APPLICATION NO: 23/01691/REM		OFFICER: Mrs Lucy White
DATE REGISTERED: 4th October 2023		DATE OF EXPIRY: 24th January 2024
DATE VALIDATED: 4th October 2023		DATE OF SITE VISIT:
WARD: Battledown		PARISH: Charlton Kings
APPLICANT:	Vistry Homes Limited And Stonewater Limited	
AGENT:	Nexus Planning	
LOCATION:	Oakley Farm Priors Road Cheltenham	
PROPOSAL:	Application for approval of Reserved Matters (access, appearance, landscaping, layout and scale) following outline planning permission for residential development of up to 250 dwellings and associated infrastructure, ancillary facilities, open space and landscaping, demolition of existing buildings and creation of a new vehicular access from Harp Hill (in accordance with the terms of outline planning permission 20/01069/OUT). Details are also submitted in relation to conditions 6 (phasing), 9 (Energy and Sustainability Statement), 13 (Harp Hill access junction details) and 25 (hard and soft landscaping and boundary treatment) of 20/01069/OUT.

RECOMMENDATION: Permit

Bin storage and access

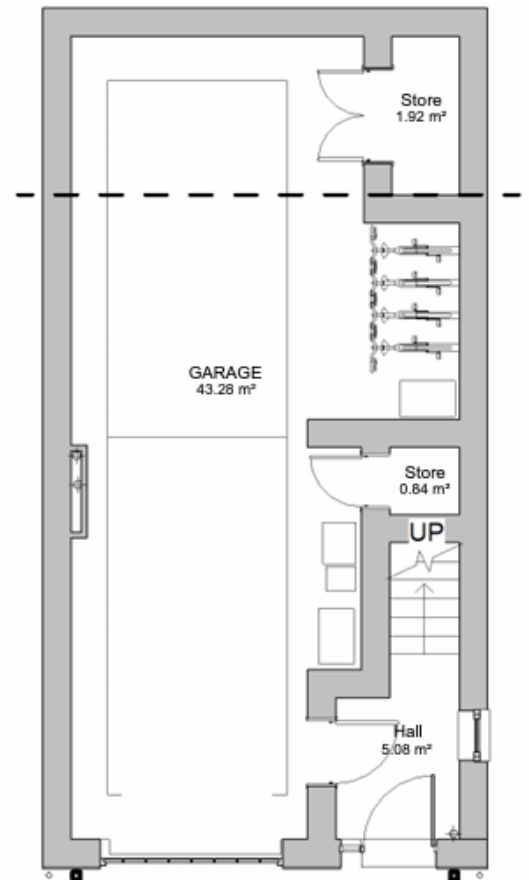
All terraced houses have front bin storage which is certainly a positive feature. We would need to see detailed plans of the construction, application of materials and sizes, to ensure that sufficient space is provided for the required bins. It might also be sensible to consider if additional storage space could be provided for EV charging cables.

1101 Front Elevation
1 : 100

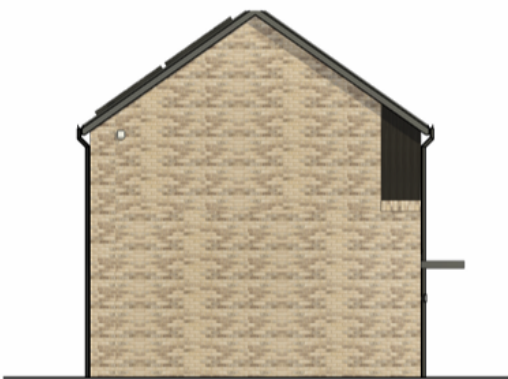
Where dark cladding is applied to the upper levels of properties, it is generally better to continue wrapping the cladding around the front and the sides (as with the Spruce Retaining GF, applied to plots 26, 28, 89 and 90, or the Chestnut No Gable type). This avoids awkward joins in prominent locations and the effect of the cladding just stopping partly around the corner, which is not a positive way to finish the effect. For example, for the mews plots including no.27 (Buckthorn), the sides should be clad, finishing into the corners. The sides, although partly concealed by the first floor amenity spaces, will still be visible as people move along the streets.

The different effects can be clearly seen within the Plot 25 (Buckthorn side balcony) elevation sheet (see below), with a more positive effect seen in the examples where cladding is applied across the whole facade.
